CALIFORNIA COASTAL COMMISSION

REGULAR CALENDAR
STAFF REPORT AND PRELIMINARY RECOMMENDATION

Application No.: 6-10-041

Description: The construction of a 38,600 sq. ft. Marine Ecosystem Sensing, Observation, and Modeling (MESOM) research and education facility, including a three story laboratory, office, conference and support space, at a location currently utilized by two parking lots (Lot Nos. P012 & P013).

EXHIBIT NO. 10

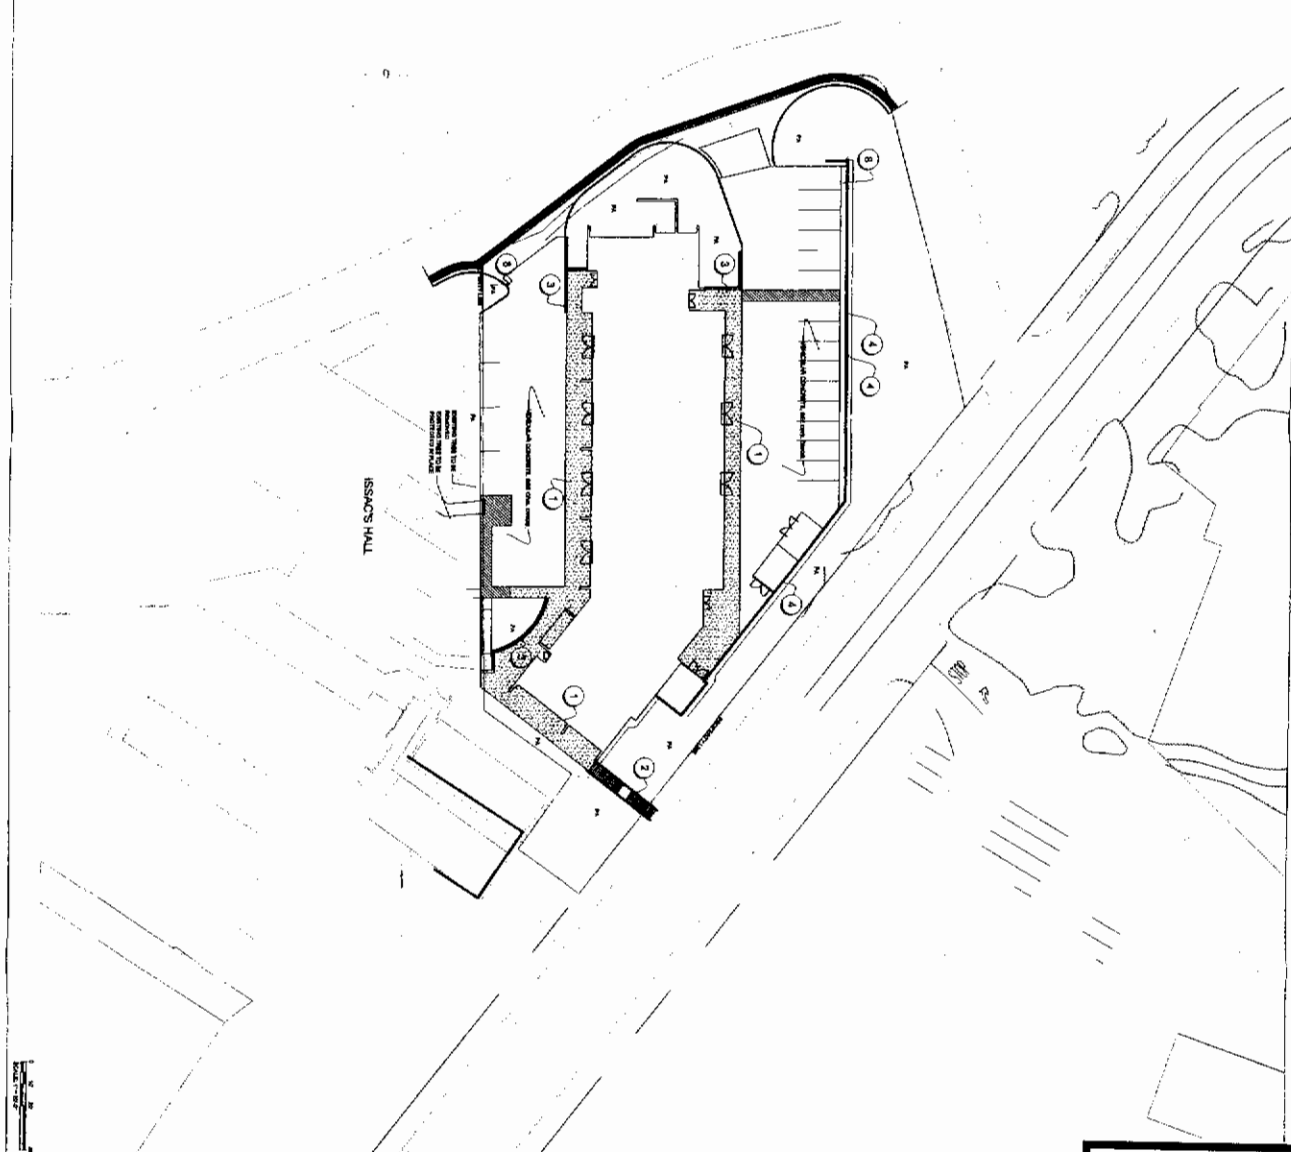
Two driveways, both accessed from Biological Grade, would provide vehicular access to the project site. The upper yard would provide the majority of parking spaces (15 spaces), and the lower yard would include parallel parking for the remaining five spaces. During periodic loading and unloading of laboratory equipment, the five parking spaces along the southern side of the building would be temporarily unavailable for automotive parking (ref. Exhibit #10).
